Notice of Administrative Decision

RE: **Permit Number:** 18-00317
Project Name: Silverdale Self-Storage - ACUP
Type of Application: Administrative Conditional Use Permit (ACUP)

Administrative Staff Report

Project Name: Silverdale Self Storage

BUILDING 1 EAST ELEVATION
SCALE: 1/8" = 1'-0"

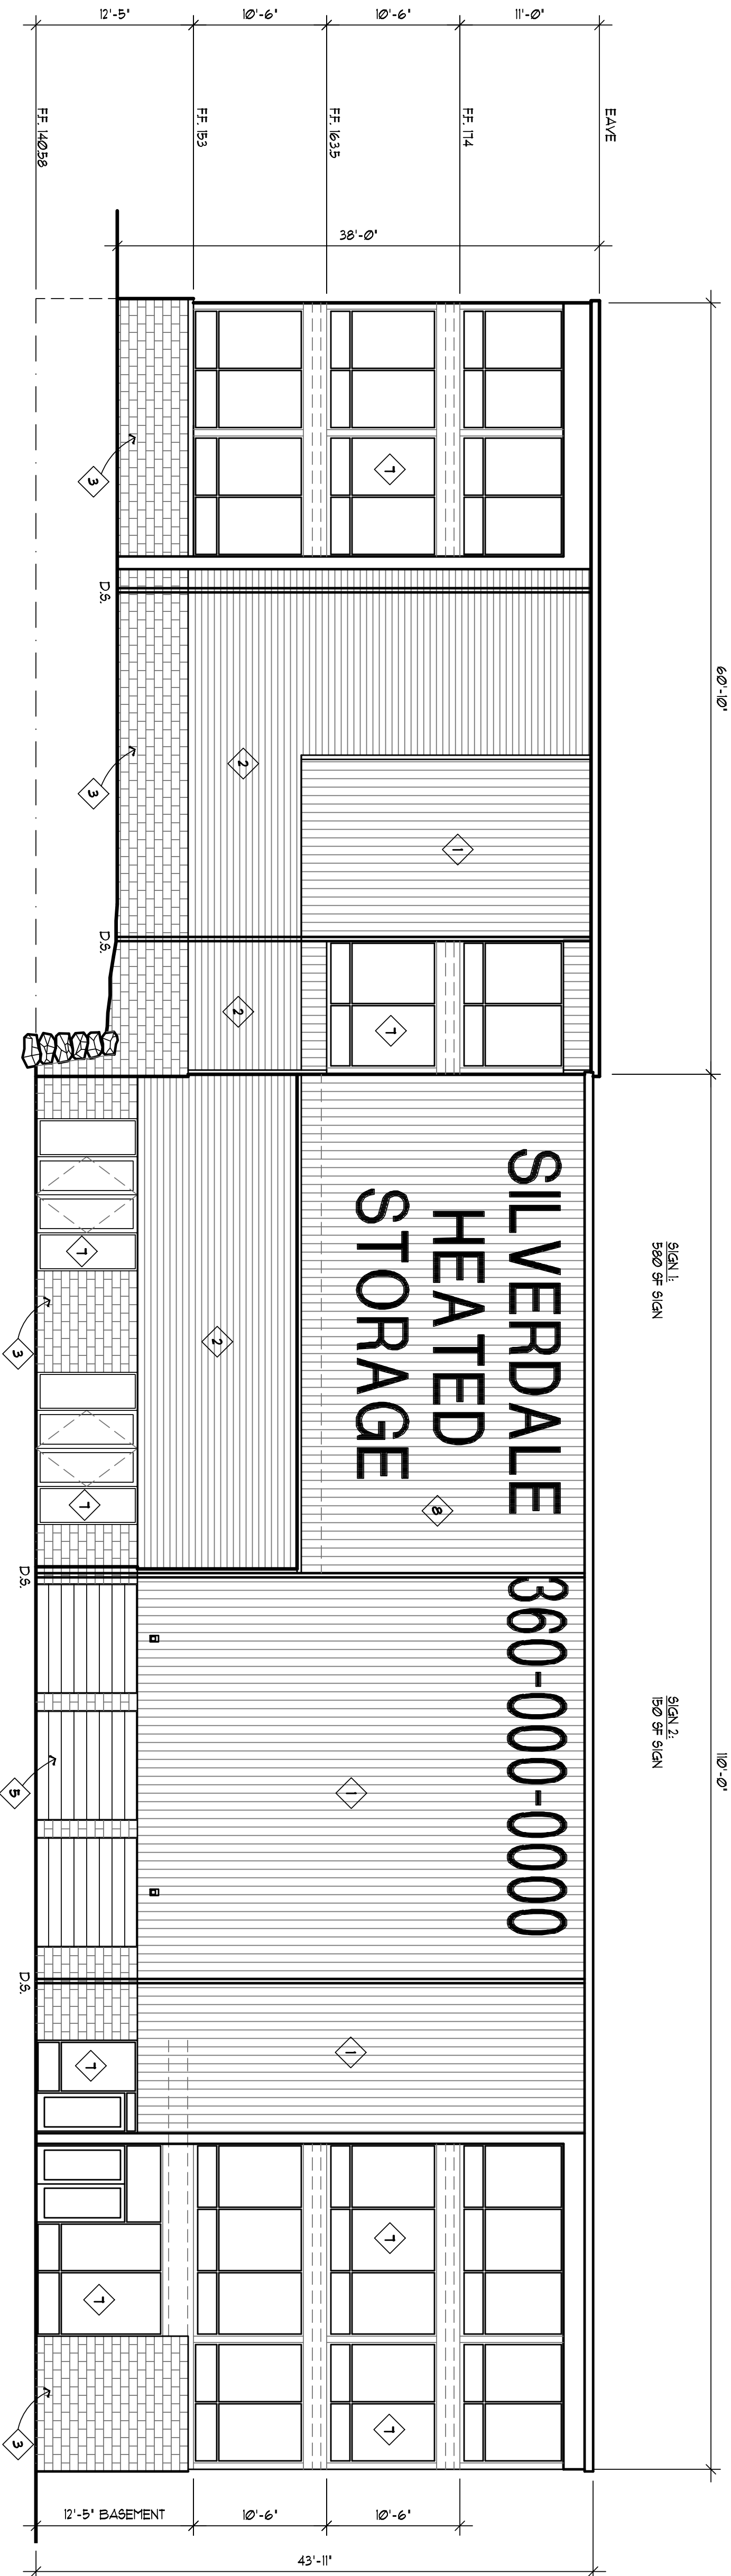
Staff Response: Only Building 1 faces the street and the ground floor total wall area is approximately 1,366 square feet (12 feet, 5 inches or 12.42 feet X 110 feet = 1,366.2 square feet); 50% of the ground floor wall area required in permeable surface is 683 square feet. The architectural drawing shows approximately 398 square feet in permeable surface. Therefore, the permeable area shown is approximately 285 square feet below the requirement. Based on the architectural drawings submitted with the ACUP, Building 1 will be conditioned to require at least 50% permeable surface wall area on the ground floor. The architect will need to show and provide the calculations for the total ground floor wall area and the ground floor permeable surface area as part of the commercial building permit for Building 1. The other alternative would be to request a variance to this standard. Based on the calculations provided above, a Zoning Variance - Administrative would be the appropriate application, which applies to a variance greater than 10% but less than or equal to 25%. For a variance to be supportable it will need to comply with the requirements outlined at KCC 17.560 Variances.

Staff Response: It is unclear if an awning or overhang is proposed over the office entrance. As a result, the project will be conditioned to provide a rain protection feature over the office entrance.

Staff Response: It is unclear if an awning or overhang is proposed over the office entrance. As a result, the project will be conditioned to provide a rain protection feature over the office entrance. Boulevard landscaping is not warranted for this project. The project is expected to provide appropriate lighting on the building to provide for customer and building safety and security.

1. All required permits shall be obtained prior to commencement of land clearing, construction and/or occupancy.
2. Commercial Building Permit 18-04330 for Building 1, east elevation, shall include a drawing that shows compliance with Silverdale Design Standards, Provost Commercial District 11.4.2(A) and includes the ground floor total wall area and the total wall area of permeable surfaces.

3. Commercial Building Permit 18-04330 for Building 1 shall include a drawing that shows compliance with Silverdale Design Standards, Provost Commercial District 11.4.2(C). Building 1 shall show a rain protection feature over the office entrance. This requirement shall be shown on the east elevation drawing.
